To: VLBA Data Acquisition Group
From: Alan E.E. Rogers and Durga Bagri
Subject: Revisions to Signal Levels in VLBA Receiving System

NORTHEAST RADIO OBSERVATORY CORPORATION HAYSTACK OBSERVATORY WESTFOOT, MASSACHUSETTS			
SIGNAL LEVELS IN VLBA RECEIVING SYSTEM			
REV.	C	54120K007	A
AER/SIGREC	DWG SIZE	DWG NO	REV.

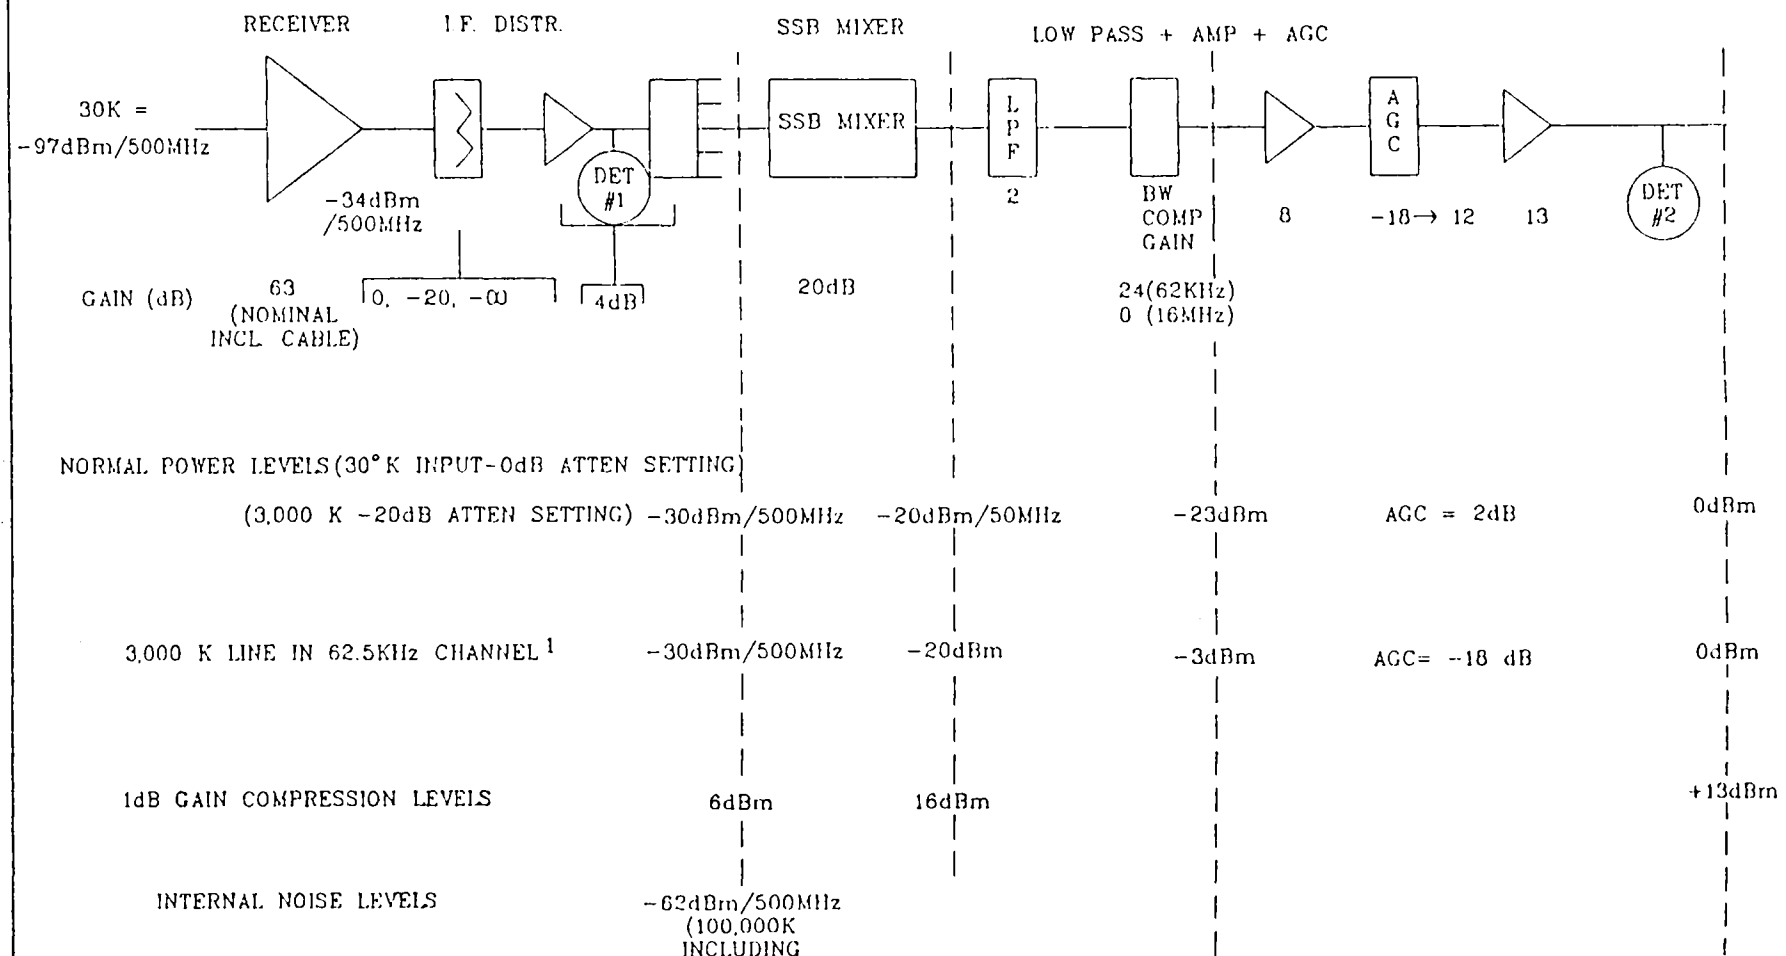
In order to extend the AGC range in the baseband converter to allow for as much as 10 dB loss of gain in the front-end the I.F. input levels to the DAR have been increased. The original reference level of -40 dBm has been increased to -34 dBm. While the front-end gain is not likely to drop by as much as 10 dB the new level allows plenty of margin to account for ripple in the front-end, imperfect cable attenuation compensation and any slow gain drifts that may occur with time. (The front-end gain can be manually adjusted but there is front-end gain control available via the MCB.)

In the original design the I.F. distributor had attenuation settings of 0, 15, 30, and 45 dB. In the interest of economy the 15 dB was taken out leaving 0 and 30 dB. Now we have changed the 30 dB to 20 dB to reduce the range over which the baseband converter has to operate. Also 20 dB attenuation is a better choice for solar observations (20 dB being the value used in the VLA).

The new signal levels are shown in Drawing 54120K007, Rev A. It should be noted that the AGC range can be extended, when observing strong spectral lines at bandwidths less than 16 MHz, by using non-standard values for the bandwidth compensation gain. One penalty for increasing the I.F. level is that the susceptibility to interference has been degraded. The worst case is a signal which falls at an I.F. frequency which is within 100 MHz of the baseband converter L.O. frequency but is outside the bandwidth selected. In this case a signal level of -71 dBm into the front end could cause 1 dB gain compression. This susceptibility level could be improved by moving some gain from the SSB mixer to somewhere after the low pass filters. This would increase the baseband converter noise contribution to its old value and possibly require the addition of extra filter stages to limit the wideband noise the amplification following the low pass filters. This needs to be investigated further. It should be pointed out however that operation in a very high interference situation may be to switch in the 20 dB attenuation in the I.F. distributor and increase the bandwidth compensation gain to compensate. In this case the 1 dB compression would be -61 dBm in the worst case.
